Hunterdon County Department of Health

Re: Septic System Alteration Waivers
Municipality: East Amwell Township
Block: 83 Lot: 3.03
Location: 533 Hamden Rd.

This department has received septic alteration plans dated October 21, 2021 designed by Bayer-Risse Engineering, Inc., to correct a malfunctioning to an existing 2 bedroom with no expansion with the use of an Advanced Treatment Unit (ATU). This design incorporates a Norweco Singular Green ATU which is adequate for a 2 bedroom dwelling and is NSF approved according to standards 40 and 245. The Board can approve the proposed design since the DEP has given the Local Boards of Health the authority to approve these technologies.

Septic System Alteration Design

**Septic System Alteration Design
 Existing & Proposed Conditions**

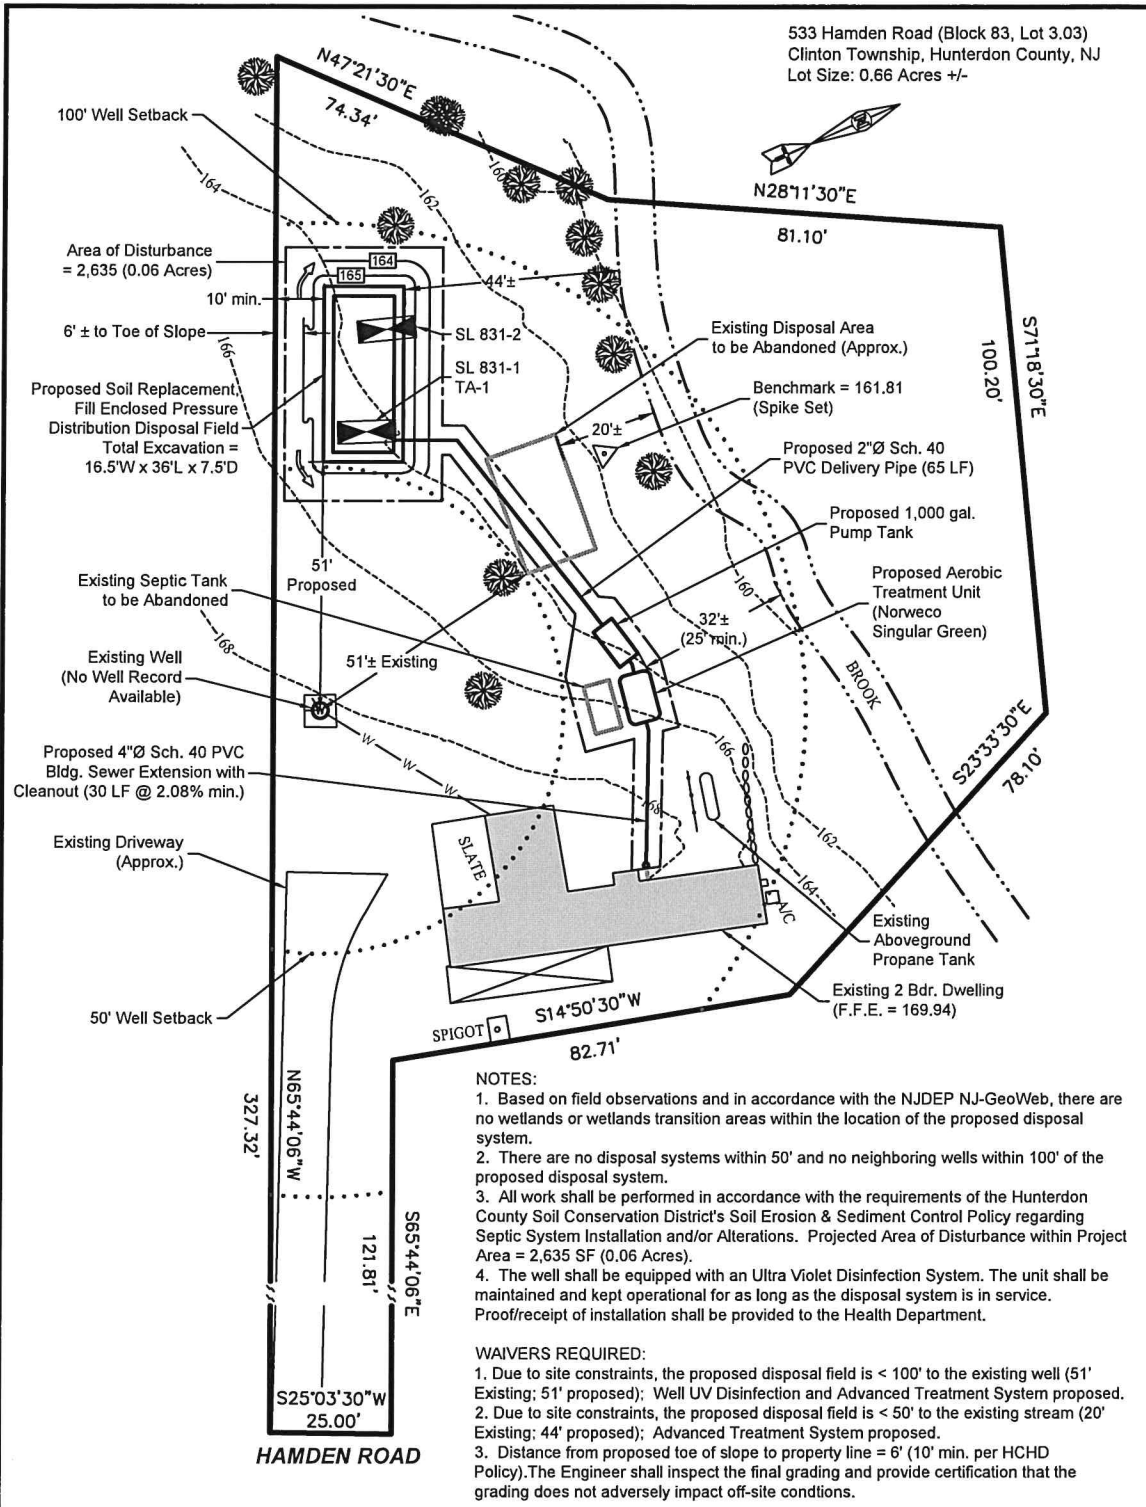
1. The proposed disposal bed toe of slope will be only 6 feet from the property line, which does not meet the minimum setback requirement of 10 feet according County policy. The engineer will inspect the grading and provide certification that the final grading has not impacted offsite conditions.

2. The proposed disposal bed will be only 44 feet from the existing stream, which does not meet the minimum setback requirement of 50 feet from a water course as per state code. The use of an ATU addresses this issue.

3. The proposed disposal bed will be only 51 feet from the existing well, which does not meet the minimum setback requirement of C100 feet. As per 7:9A-4.3, the distance can be reduced to 50 feet provided there is 50 feet of casing. Since there is no well record available, the engineer has proposed an ultra violet device on the well with added protection. A water test for coliform shall be done after installation.
